Delegated Report

Planning Application No: 20220753

Location: Westdene Cottage Tanyard Hill Shorne Gravesend

Description: Application for approval of condition 8 and 9 attached to planning permission reference number 20200830 relating to a scheme detailing the hard landscaping and a scheme detailing the proposed soft landscaping

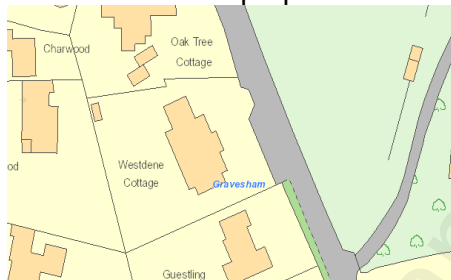
The KCC Highways map (extract below) shows that, in contrast to the proposed plans, part of the area in this proposal is actually roadway under KCC control:

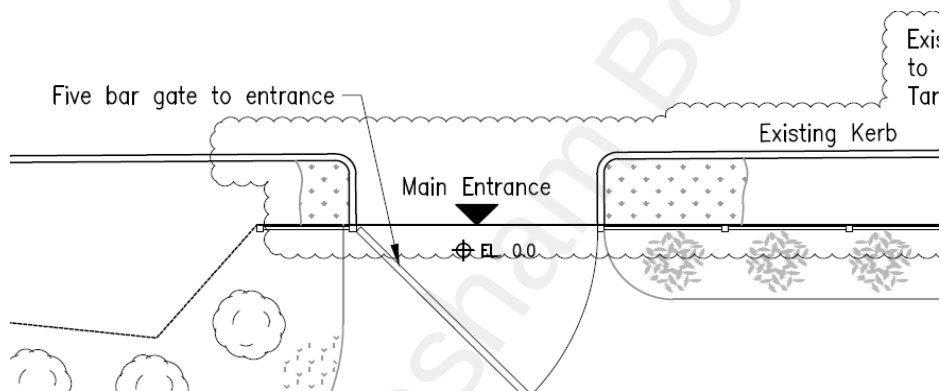
The Google streetview image (May 2012) shows the situation prior to works being commenced:

This layout/verge should be restored (as originally expected) with the grassed verge footway clear and at least 1m wide throughout, lined up with the properties either side.

In response to the comments received from Shorne Parish Council, Dickens' Country Protection Society and KCC – Highways and Transportation, a revised plan was submitted to address the issues raised. The revised plan shows clearly the reinstatement of the grass verge which would address the comments relating to being KCC – Highways land. The driveway materials are shown to be bonded within 5m of the highway and the vehicular access gate is shown to be set further back and vision splays, which addresses the concerns of the Parish Council and KCC – Highways. The visibility splays have been clearly shown which addresses the Parish Council's concerns and accords with the advice given by KCC - Highways. With respect to soft landscaping, the revised plan shows the retention of the south boundary hedging and the tree located within the front, together with new planting to the front, side and rear and a schedule of
